**Amendment No 1 (05/2025)**  
**To**  
**AIS-195 Standard**

**SAFETY AND PROCEDURAL REQUIREMENTS FOR TYPE APPROVAL  
OF HYDROGEN POWERED VEHICLES (LIQUID / COMPRESSED  
GASEOUS HYDROGEN)**

7<sup>th</sup> May 2025

Figure: Generic Description of Test Pulses

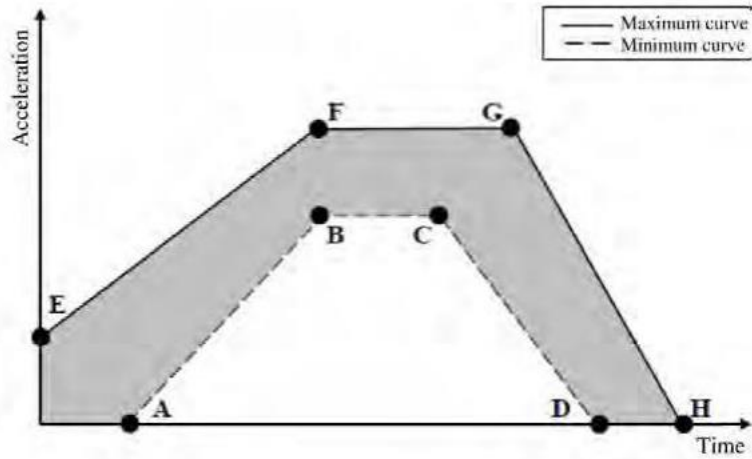
- 7.2.3 In case that one or more directions of the vehicle crash tests specified above are not applicable to the vehicle, the CHSS shall, instead, be subject to the relevant alternative accelerations in compliance with the acceleration corridors which are specified in Tables below in both positive and negative directions. The accelerations shall be measured at the location where the CHSS is installed. The CHSS shall be mounted and fixed on the representative part of the vehicle. The mass used shall be representative for a fully equipped and filled CHSS.

The test pulse shall be within the minimum and maximum value as specified in Tables below. A higher shock level and/or longer duration as described in the maximum value in Tables below can be applied to the CHSS if recommended by the manufacturer.

Point	Time (ms)	For M1 and N1 vehicles		For M2 and N2 vehicles		For M3 and N3 vehicles	
		Acceleration (g)		Acceleration (g)		Acceleration (g)	
		Longitudinal	Transverse	Longitudinal	Transverse	Longitudinal	Transverse
A	20	0	0	0	0	0	0
B	50	20	8	10	5	6.6	5
C	65	20	8	10	5	6.6	5
D	100	0	0	0	0	0	0
E	0	10	4.5	5	2.5	4	2.5
F	50	28	15	17	10	12	10
G	80	28	15	17	10	12	10
H	120	0	0	0	0	0	0
